**August 21, 2014
BOARD OF COUNTY COMMISSIONERS
ORANGE COUNTY, FLORIDA**

**ADDENDUM NO. 8
IFB NO. Y14-748 PH
ORANGE COUNTY EASTERN WATER RECLAMATION FACILITY
PHASE V AND CENTRIFUGE DEWATERING IMPROVEMENTS**

G-004

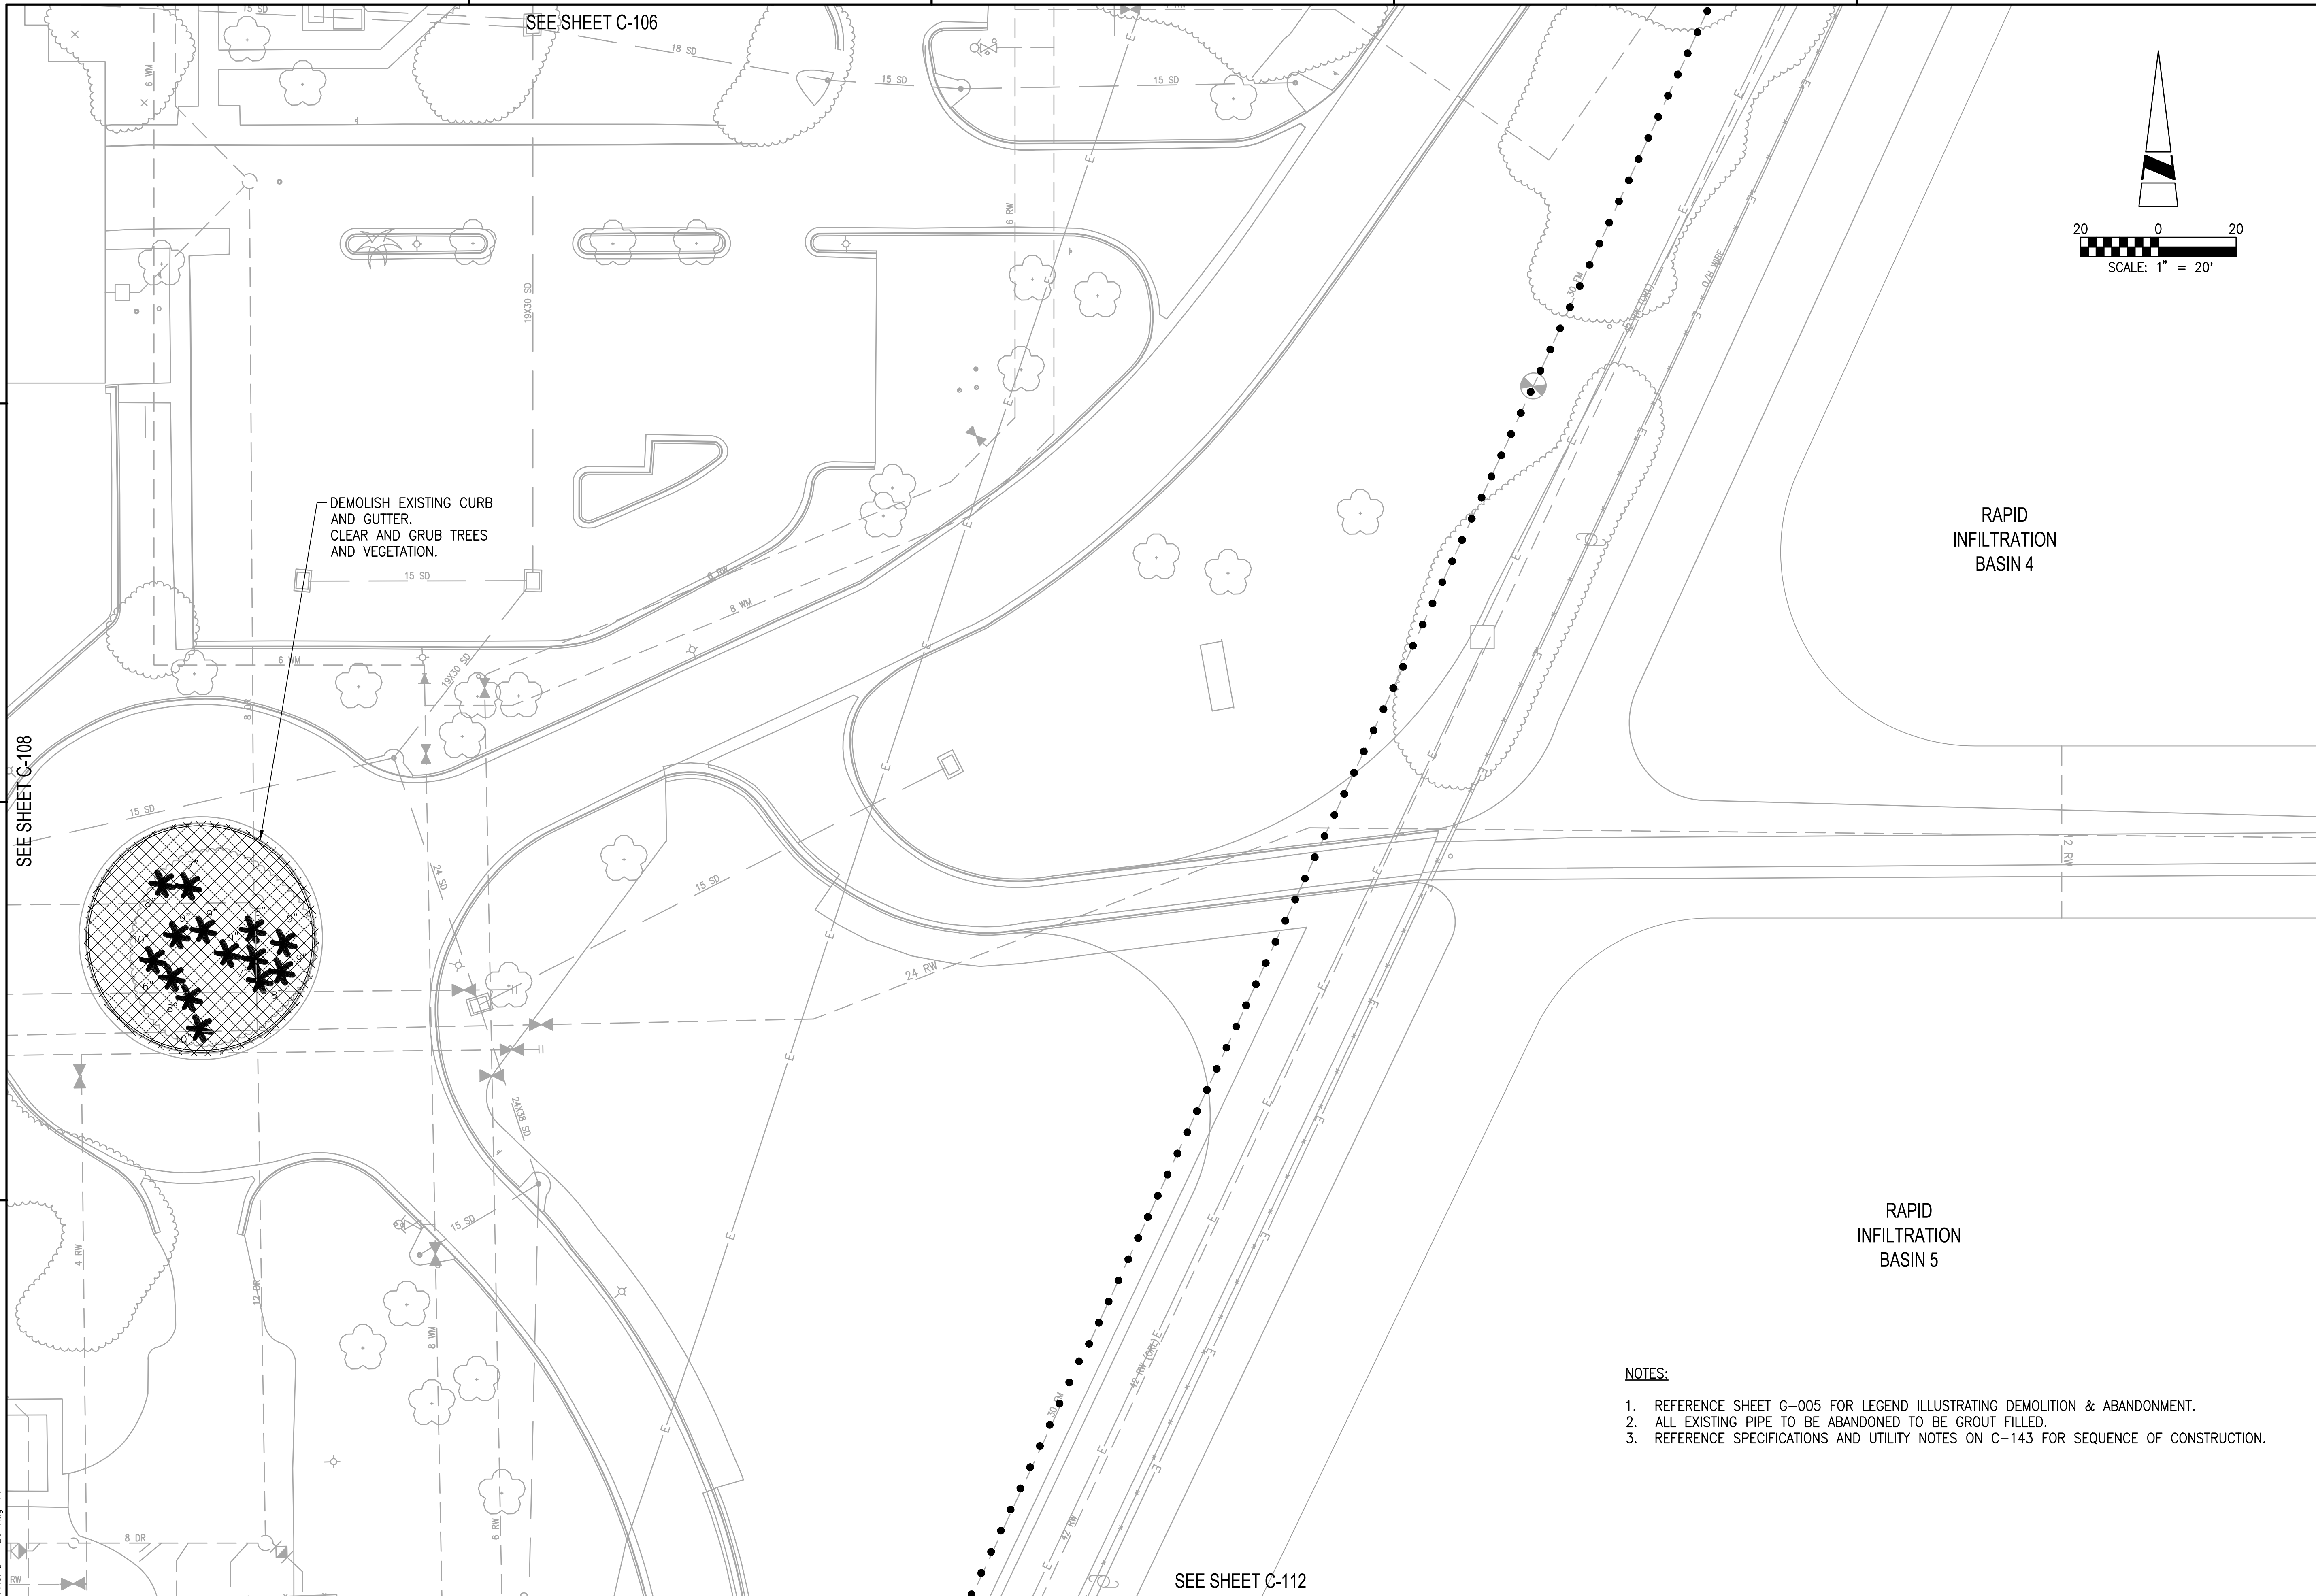
46. Bid Packages A & B: Per the engineer's response to question 137 in Addendum No. 6, we would like to clarify that it is the engineer and owner's intent for the contractors to hand dig within 7' of existing structures. This note will add significant cost to this project, and likely extend the duration. There are multiple instances in which this note affects production within the scope of work. Take a moment to look at SEC Clarifiers 1-2 and 3-4, the tie in's to the RAS-1 lines are 10-12'+ below grade, per note 2 on sheet S-250-101, the engineer is requiring sheeting and tie backs to protect this structure during the excavation. Is it our understanding, that we can drive sheets underneath a launder wall, with no clearance, within 7' of an existing structure, but cannot excavate? We would ask that this note be deleted, as this is a means and methods decision by the contractor, as the contractor already assumes all risk for existing structures and processes within the scope of work.

Noted. Orange County Utilities rational behind inserting the note is for the congestion in certain areas that will likely require hand excavation due to close proximity to existing facilities; pipeline and ductbanks. General Note 26 on Drawing G-004 and G-002 in Bid Packages A and B respectively is revised as follows; 26. ~~IT IS THE RESPONSIBILITY OF THE CONTRACTOR TO INCLUDE IN THE BID TO EXCAVATE BY HAND ALL AREAS. THE CONTRACTOR IS ADVISED THAT HAND DIGGING MAY BE THE ONLY METHOD AVAILABLE TO AVOID PIPELINE AND ELECTRICAL DUCTBANK DESTRUCTION IN MANY CONGESTED AREAS. (Attachment)~~

C-109
 21 OF 527

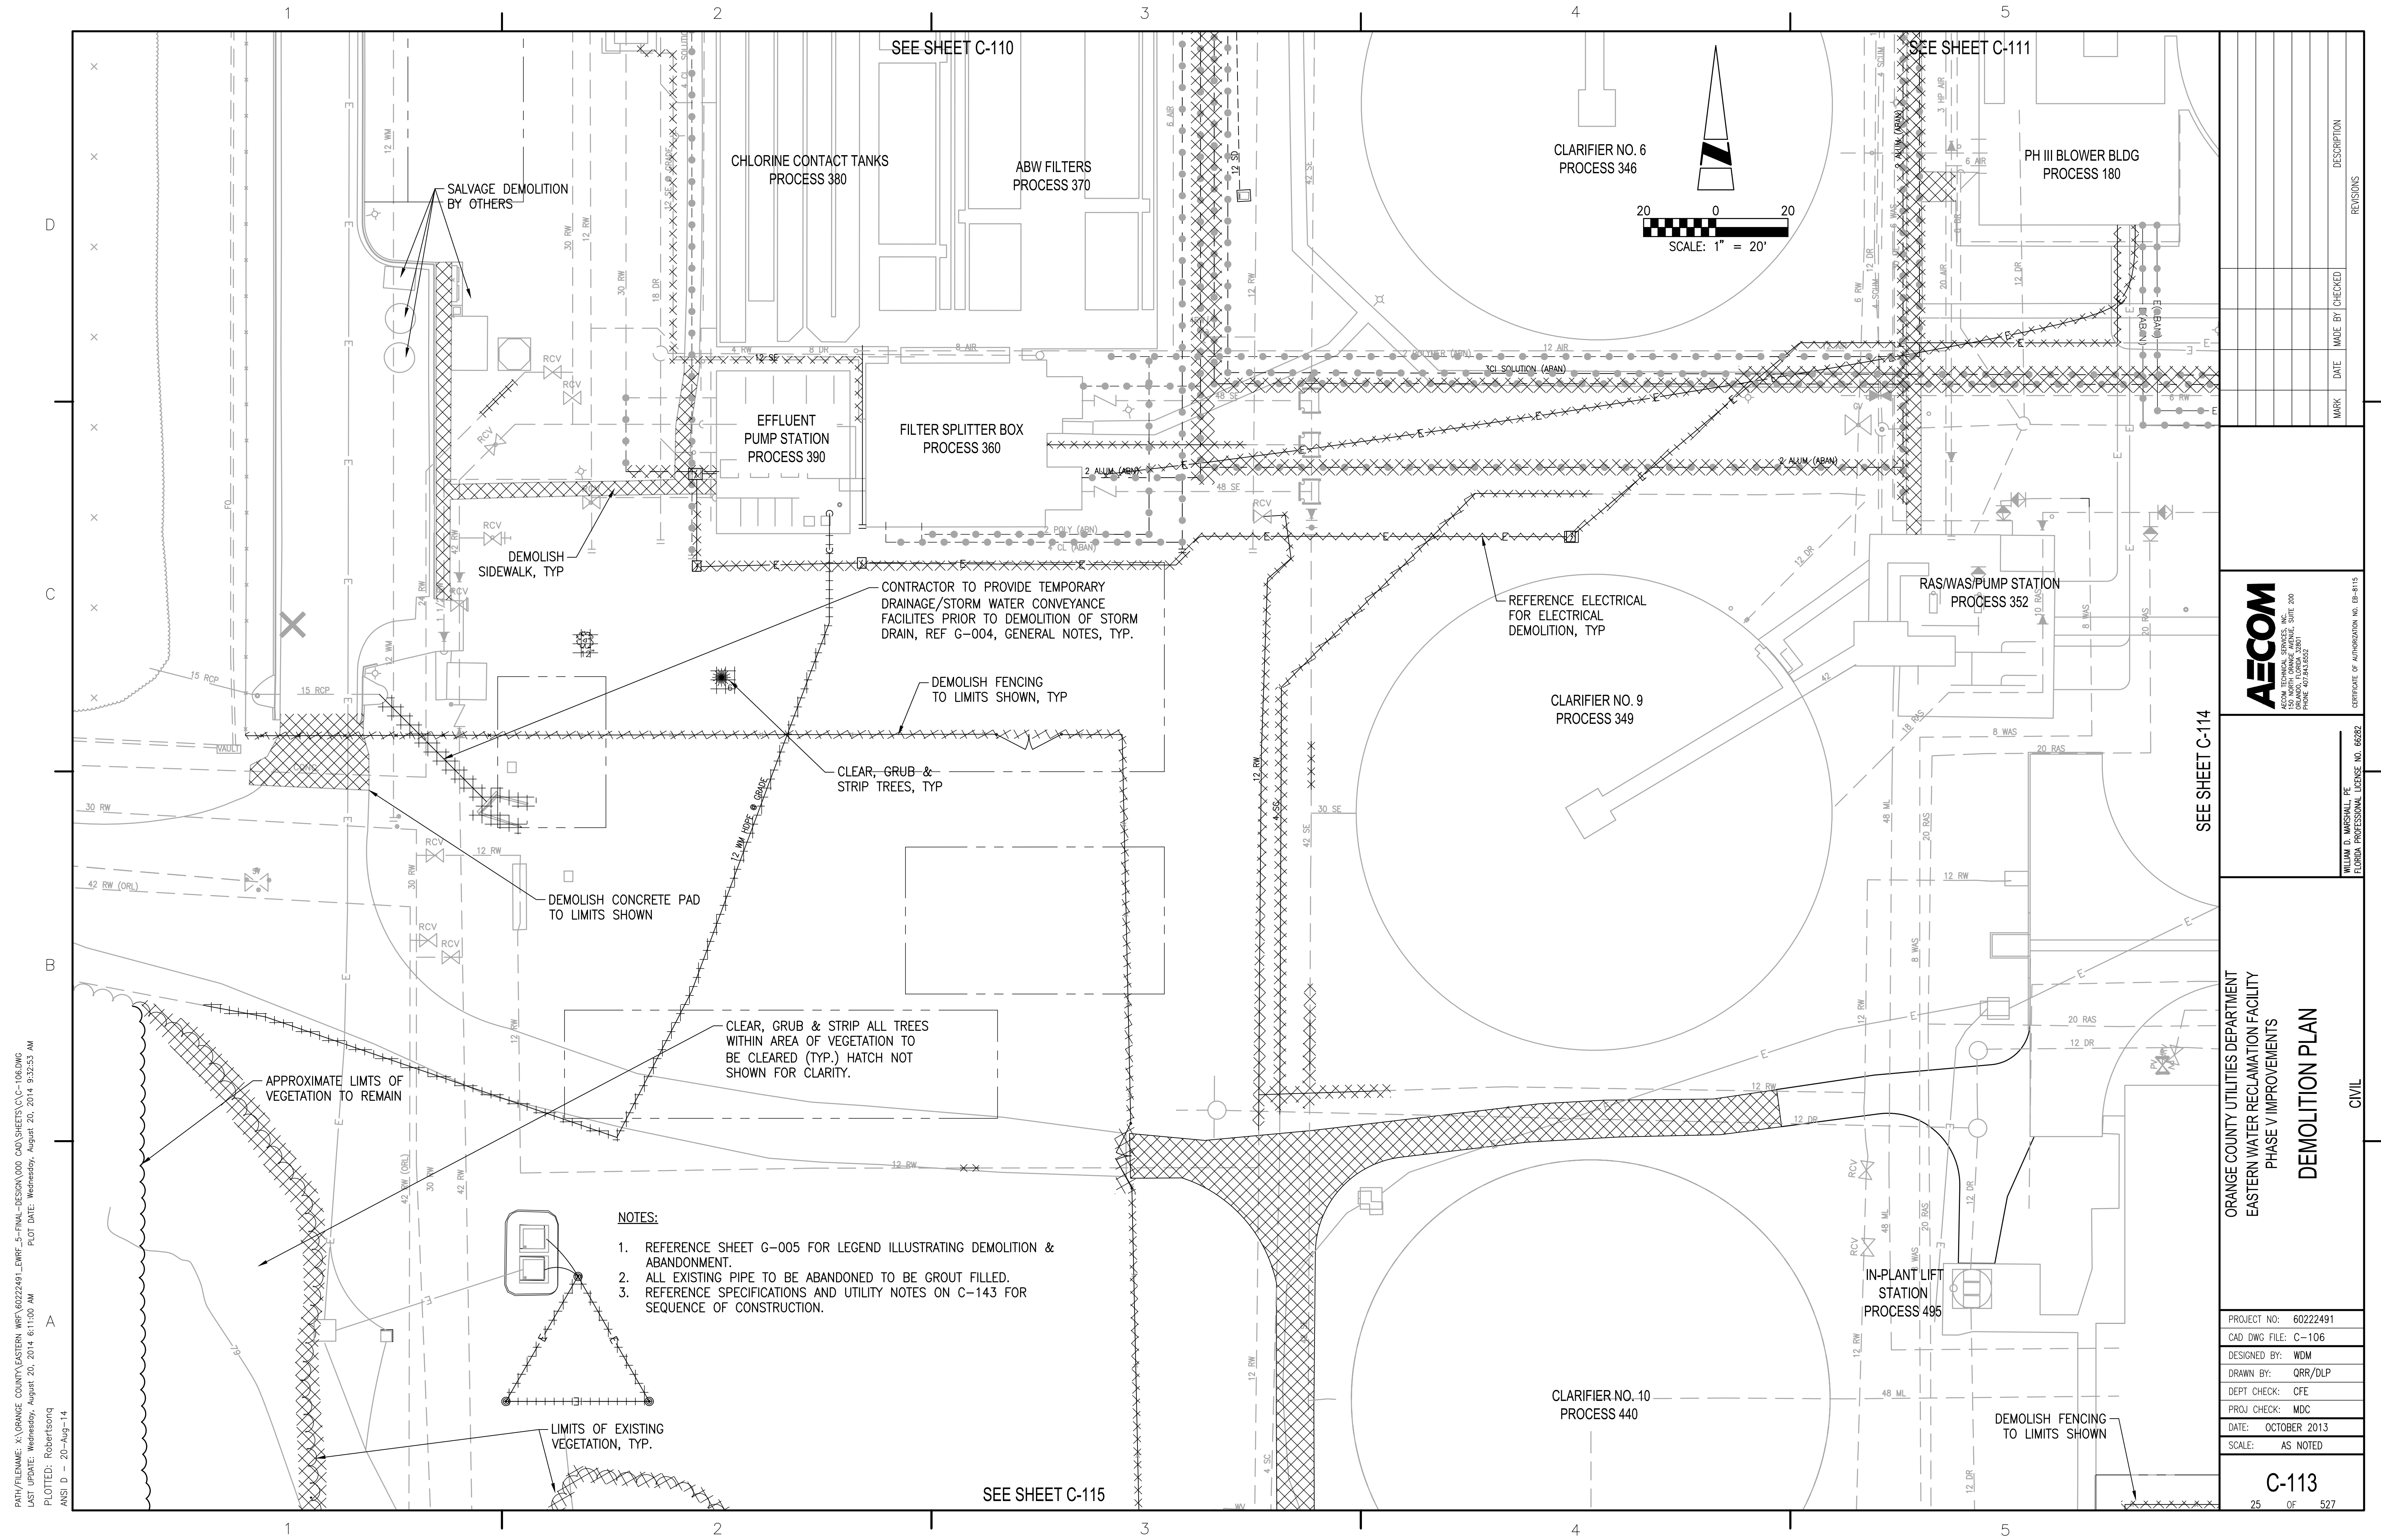
16. Bid Package A: Drawing C-113 shows a portion of the asphalt roadway to be removed. However, drawing C-135 appears to show a new road including a soil cement base and 2" of asphalt where the existing road is not demolished. Please clarify which areas of asphalt shall be removed and/or milled and which areas receive a new road and base.

*The demolition hatch for the existing roadways on Drawings C-109 and C-113 is deleted. The following Note is applied to all of the Yard Piping Drawings C-117 through C-127; UTILITIES INSTALLED WITHIN EXISTING ROADWAYS SHALL INCLUDE ROADWAY RESTORATION WITHIN A DURATION OF TIME AS DESIGNATED BY THE RPR AND DETAILS 6/C-503 AND 4/C-503. Drawings C-117, C-131 and C-135 are revised to eliminate the dark hatch in the prior areas Detail 6/C-503 was called out and hatched in the light hatch for the 1" S-III mill and overlay. **(Attachment)***
